318 58 FURY

SERVICE BULLETIN

No. 1003-CH CORRECTION

Automatic
Transmission
Lubrication &
Servicing
Instructions

FIGURE 1

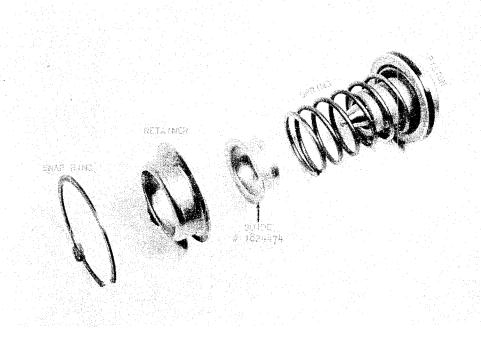
There is a possibility that on some 1957 Torque-Flite Transmissions built prior to code letter "F" that the reverse servo will cock over and subsequently miss the pilot hole on the reverse band lever.

Whenever there is a failure of the reverse servo piston, Reverse Servo Piston Guide Part No. 1824474 must be installed to prevent a recurrence of the failure. (See Figure 1)

Further, at any time a 1957 Torque-Flite Transmission built prior to code letter "F" is disassembled for service for any reason, the piston guide No. 1824474 should be installed.
